**SB-18-032 CONVENTIONAL DTC P2483
WORKSHOP MANUAL CORRECTION**

**GROUP: SERVICE MANUAL UPDATE
BULLETIN NO: SB-18-032
DATE: 12-18-2018
REF: SB-A-11-090**

SUBJECT VEHICLES: 2018MY-2019MY Conventional Trucks equipped with an J08E.

Workshop manual correction of DTC P2483 inspection procedure and troubleshooting information.

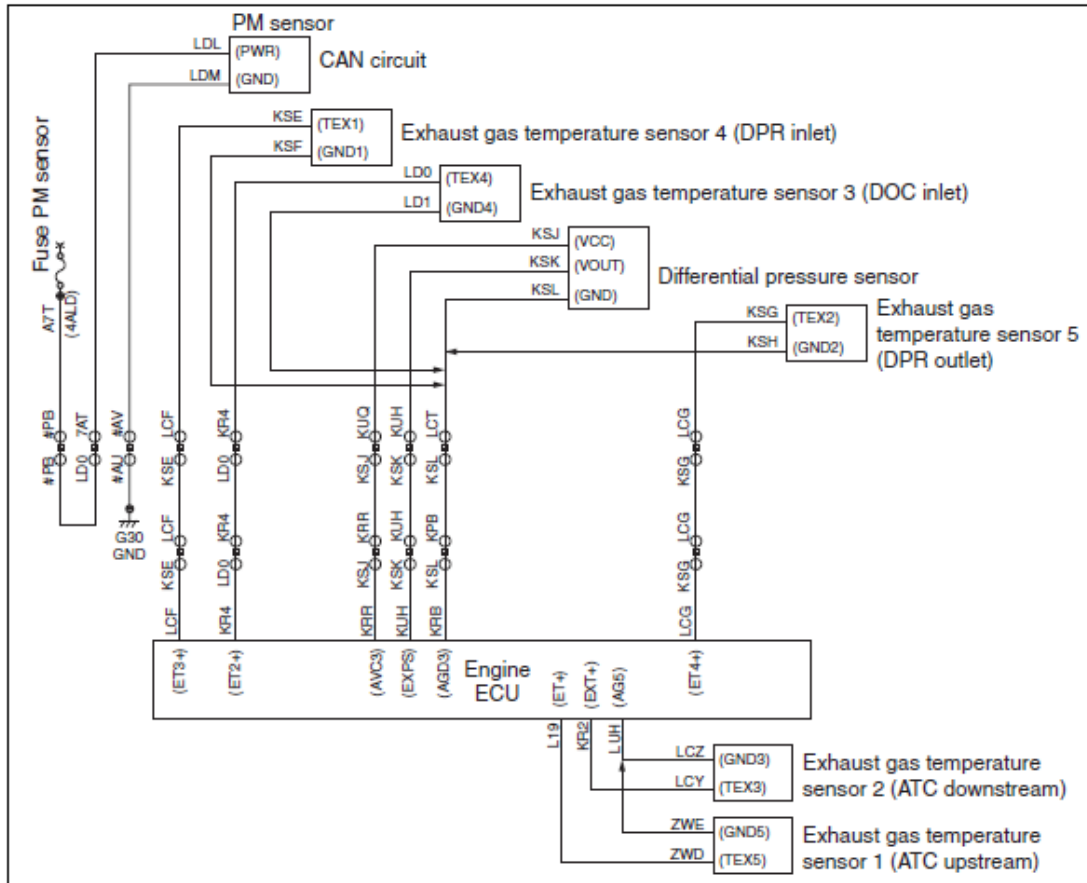
- Battery voltage is in the range of 11 V to 16 V.
- Starter switch ON.
- Engine off.
- Difference between engine coolant temperature and intake temperature is within $\pm 8^{\circ}\text{C}$ ($\pm 14.4^{\circ}\text{F}$) for 8 seconds after the engine start.
- The difference between the engine coolant temperatures before the engine start and at present is 30°C (54°F) or more.
- Engine coolant temperature is at least -10°C (-14°F).
- Intake air temperature is at least -10°C (-14°F).

- Difference between exhaust gas temperature sensor 1 (ATC upstream) and exhaust gas temperature sensor 2 (ATC downstream) stays less than $\pm 50^{\circ}\text{C}$ ($\pm 90^{\circ}\text{F}$).
- Difference between exhaust gas temperature sensor 2 (ATC downstream) and exhaust gas temperature sensor 3 (DOC inlet) stays less than $\pm 50^{\circ}\text{C}$ ($\pm 90^{\circ}\text{F}$).
- Difference between exhaust gas temperature sensor 3 (DOC inlet) and exhaust gas temperature sensor 4 (DPR inlet) stays less than $\pm 50^{\circ}\text{C}$ ($\pm 90^{\circ}\text{F}$).
- Difference between exhaust gas temperature sensor 4 (DPR inlet) and exhaust gas temperature sensor 5 (DPR outlet) stays more than $\pm 50^{\circ}\text{C}$ ($\pm 90^{\circ}\text{F}$).
The conditions described above remain for 1 seconds ore more.

- Battery voltage is in the range of 11 V – 16 V.
- The engine speed remains at 500 r/min or more for 5 seconds or more.
- The difference between the engine coolant temperature and intake air temperature is more than 8°C (14.4°F).
- Exhaust gas flow quantity \geq 500 kg/h.
- Engine speed \geq 1,750 r/min.
- Fuel injection amount \geq 15 mm³/st. cyl.
- Exhaust gas temperature sensor 3 (DOC inlet) is valid.

In addition, the following conditions continue for at least 10 seconds:

- Engine speed variation is within 625 r/min.
- Fuel injection quantity variation is within 625 mm³/st. sec
- Vehicle speed \geq 30 km/h (19 mph).

- Difference between the calculated exhaust gas temperature sensor 5 (DPR outlet) and actual exhaust gas temperature sensor 5 (DPR outlet) stays more than 80°C (144°F).
The conditions described above remain for 3 seconds or more.
